Landmarks Commission  
Meeting of July 13, 2020  
Legistar 59708, Agenda item #2, 817-821 Williamson St.

### Revised plans dated 7-13-20 (Legistar document #27)

Streetview of 803-811 Williamson Street illustrating a similar street façade height

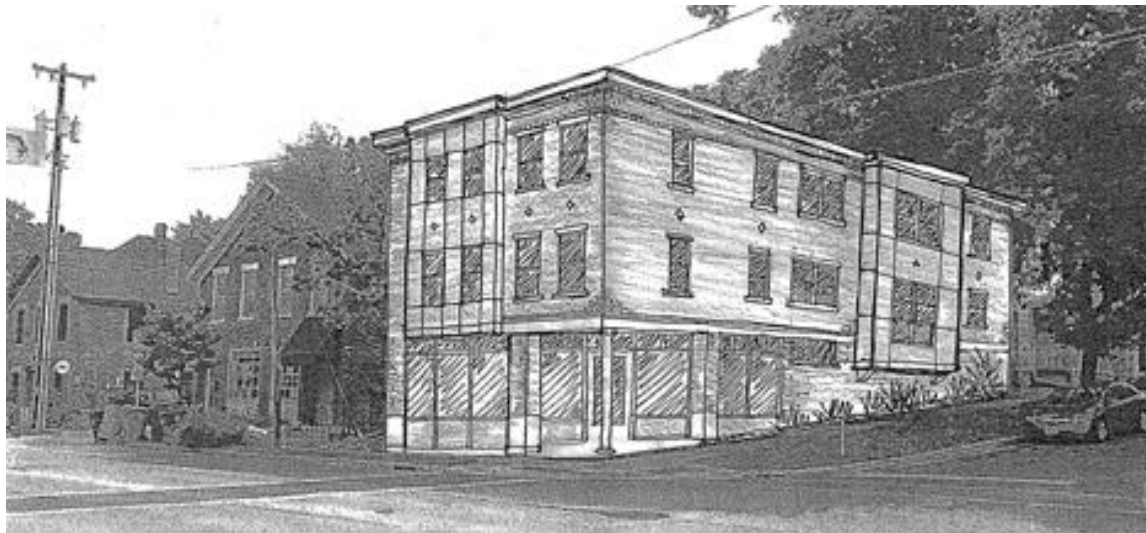
What is interesting is how much higher the building actually is as compared to what was presented to, and voted on by, the LC (in particular, compare the phone/power lines).
